**TSG-RAN Meeting #17**  
**Biarritz, France, 3 - 6 September 2002**

**RP-020550**

**Title:** Agreed CR (Release '99 only) to TS 34.109  
**Source:** TSG-RAN WG2  
**Agenda item:** 7.2.3

<b>Title:</b>	# Correction of figure 5.3.2.6.1.1		
<b>Source:</b>	# TSG-RAN WG2		
<b>Work item code:</b>	# TEI	<b>Date:</b>	# 2002-08-22
<b>Category:</b>	# <b>F</b>	<b>Release:</b>	# R99
	Use <u>one</u> of the following categories:		Use <u>one</u> of the following releases:
	<b>F</b> (correction)	2	(GSM Phase 2)
	<b>A</b> (corresponds to a correction in an earlier release)	R96	(Release 1996)
	<b>B</b> (addition of feature),	R97	(Release 1997)
	<b>C</b> (functional modification of feature)	R98	(Release 1998)
	<b>D</b> (editorial modification)	R99	(Release 1999)
	Detailed explanations of the above categories can be found in 3GPP TR 21.900.		Rel-4 (Release 4)
			Rel-5 (Release 5)
			Rel-6 (Release 6)

**Figure 5.3.2.6.1.1: Loop back of PDCP SDU (DL RLC SDU size = UL RLC SDU size = N)**

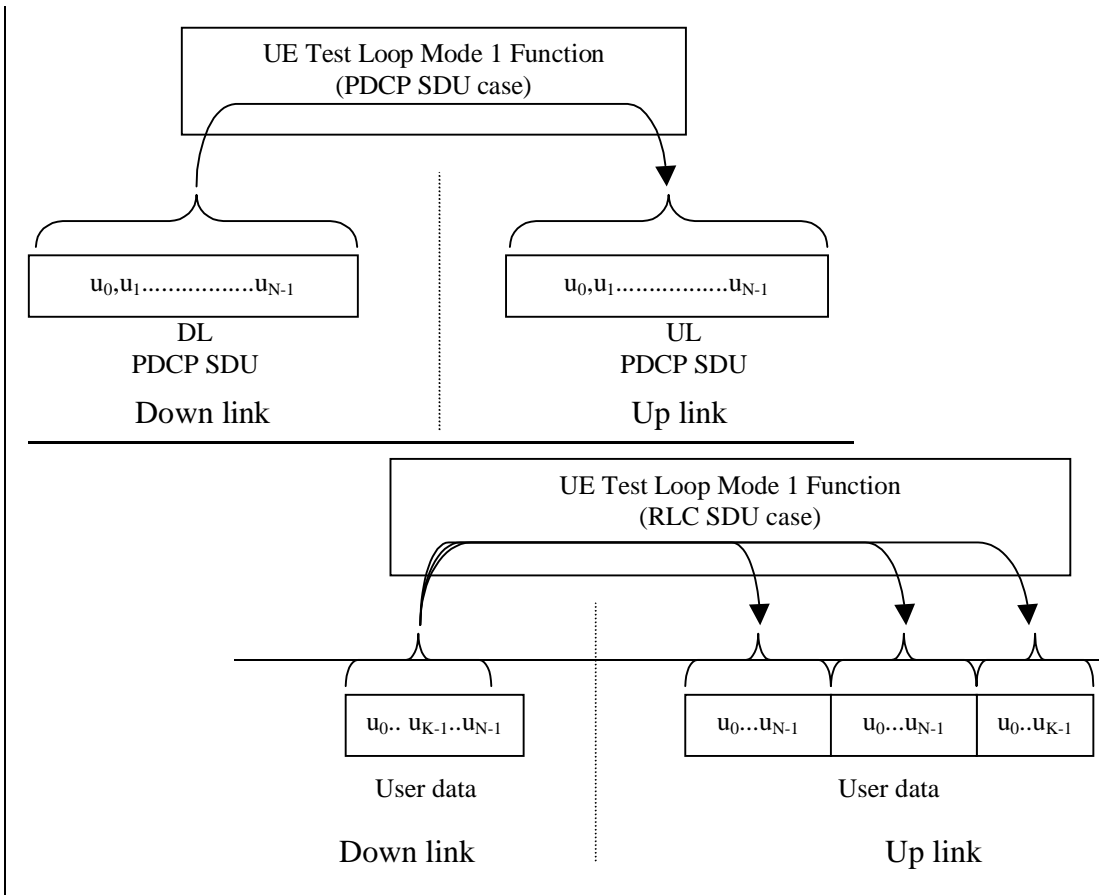
<b>Reason for change:</b>	# Error introduced in CR 11 to figure 5.3.2.6.1.1 as pointed out by T1 in T1S-020447.
<b>Summary of change:</b>	# Figure 5.3.2.6.1.1 changed to reflect the PDCP SDU loop back case where the returned uplink PDCP SDU is the same size as the downlink PDCP SDU. The current figure was by mistake introduced in CR 11 to version 3.4.0 of 34.109.
<b>Consequences if not approved:</b>	# Figure does not illustrate the PDCP loop back case correctly.
